Item Name: Fwd Crosstube - High 407

DRAWING NO. D407-667-145	TITLE CROSSTUBE ASS'Y (407 HIGH FWD)	REV. C	DART AEROSPACE LTD ENGINEERING ORDER		D.E.O. NO. D407-667-145-C-1	SHEET NO. SHEET 1 OF 1	SCALE NTS
DRAWN 97	CHECKED 155	MFG. APPR. 155	APPROVED 155		DE APPR. 155		
DATE 11.07.15	DATE 11.07.22	DATE 11.07.22	DATE 11/07/22		DATE 11.07.21

DRAWING NO. D407-667-145	TITLE CROSSTUBE ASS'Y (407 HIGH FWD)	REV. C	DART AEROSPACE LTD ENGINEERING ORDER		D.E.O. NO. D407-667-145-C-2	SHEET NO. SHEET 1 OF 1	SCALE NTS
DRAWN AJS	CHECKED	MFG. APPR.	APPROVED		DE APPR.		
DATE 12.08.02	DATE 12.08.02	DATE 12.08.02	DATE 12.08.02		DATE 12.08.02

DETAIL P
BONDING STRAP INSTALLATION 2 PL

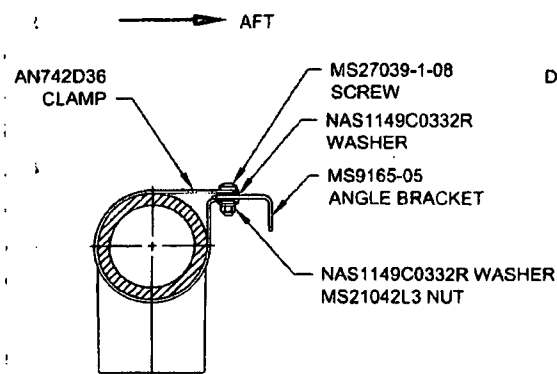
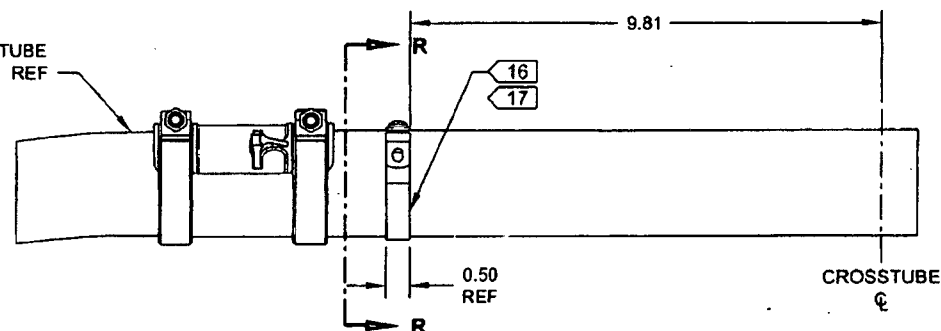
ADD ELECTRICAL GROUNDING STRAP

ADD

ADD
